Product End of Life Notice

CUB1 to CUB7 Counter Comparison

Comparison of CUB1 Counter and CUB7 Counter

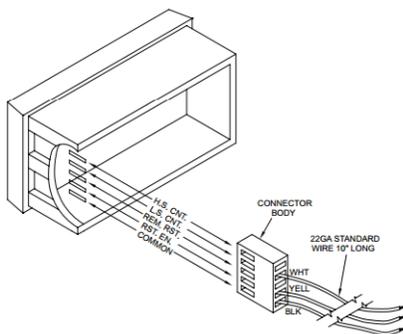
The CUB7 counter is the designated replacement for the CUB1 counter. The chart below compares the features of the 2 products.

CUB1 Counter	CUB7 Counter
Part Number	CUB10000	CUB7CCS0
Power	2 "N" size replaceable batteries, with nominal 4 year life	Non-replaceable Lithium ion battery, with nominal 7 year life
Construction	Metal bezel	Plastic
Connections	Wires	Wires or terminal block
Input Flexibility	Low or high speed set with wire input	One input, with speed selectable via DIP switch
Count Speed	5 kHz	5 kHz
Display Type	Reflective	Reflective
Display Height	0.2 in	0.35 in
Mounting Considerations		Direct replacement
List Price	\$ 93.00	\$ 50.00
